Record of Executive Business and Chief Executive's Order

Reg. Reference: SD21A/0315 **Application Date:** 18-Nov-2021
Submission Type: Additional **Registration Date:** 09-Jun-2022
Information

Proposed Development: 2 storey detached dwelling on site to side of existing
detached dwelling incorporating new vehicular
entrance to front garden to off street car parking; all
associated site works.

Location: 22, Killakee Green, Dublin 24

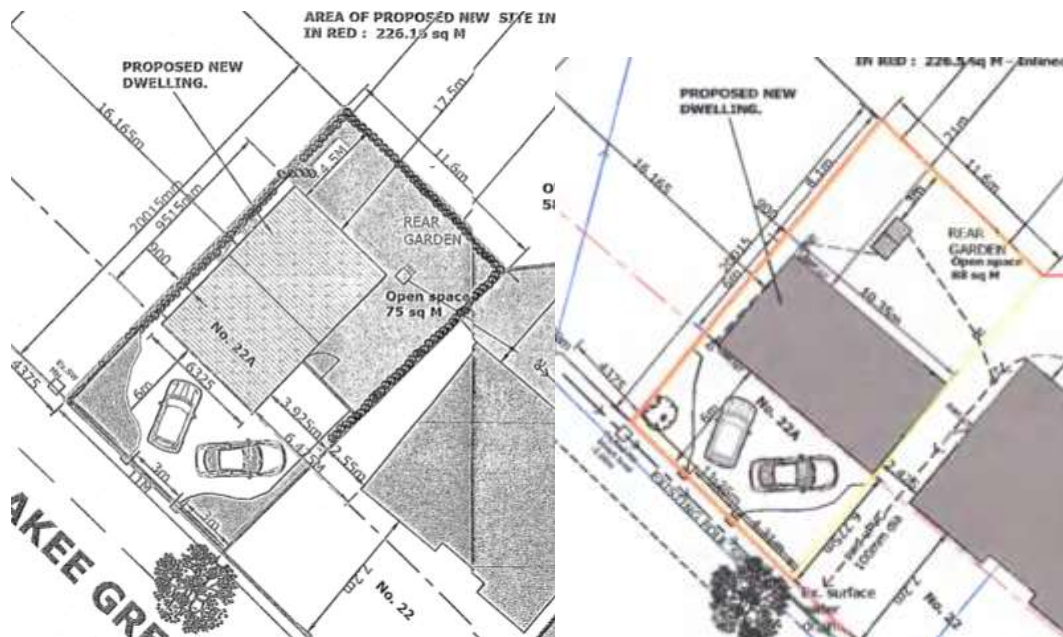
- The rear windows on the proposed northeastern elevation have reduced in size in order to address any potential overlooking of the property to the rear which will lead onto two WC's and shall be obscured into perpetuity by way of condition. An additional window has been included between ground and first floor levels to allow light to the stairwell which although could be increased to provide a more prominent architectural feature to the rear elevation, is considered acceptable.
- **The ridge height has increased as a result of the revised design layout from 8.765m to 9.15m.** It is considered that the ridge height of the proposed development was overbearing in the original proposal and increasing this will exacerbate this issue which is unacceptable to the Planning Authority. vicinity.

The applicant has made substantial changes to the proposed development that were not specified by the Planning Authority when requesting additional information which would require readvertisement including raising the ridge height to a level which is unacceptable to the Planning Authority and would seriously injure the visual amenity of the surrounding area. It appears also that the width of the front of the site has increased from 11m to 11.25m. In addition to this, Additional Information was requested on 21st of January 2022 and the timeframe for the return of clarification of additional information required would render this unfeasible. Therefore, a **refusal of permission** is recommended.
